Correction to “Systematic Design of Active Constraint Switching Using Classical Advanced Control Structures”

Ind. Eng. Chem. Res. 2020, 59 (6), 2229–2241, DOI: 10.1021/acs.iecr.9b04511

Figure 21. Alternative control structure for distillation column (all regions). This structure behaves differently from that in Figure 18 when maximizing throughput (region IV).

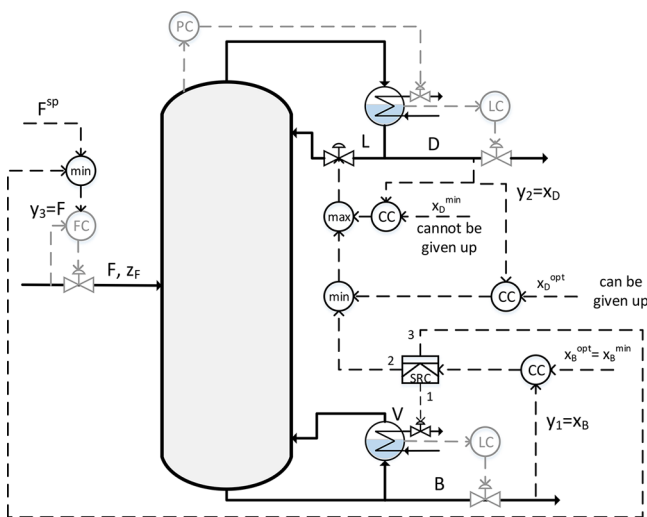
Page 2240. In the published version of this paper, with regard to Figure 21, there is a missing dashed line going from the SRC block (signal 3) to the *min* selector block that gives the set point to the inlet flow controller (FC). The correct figure should appear as follows:
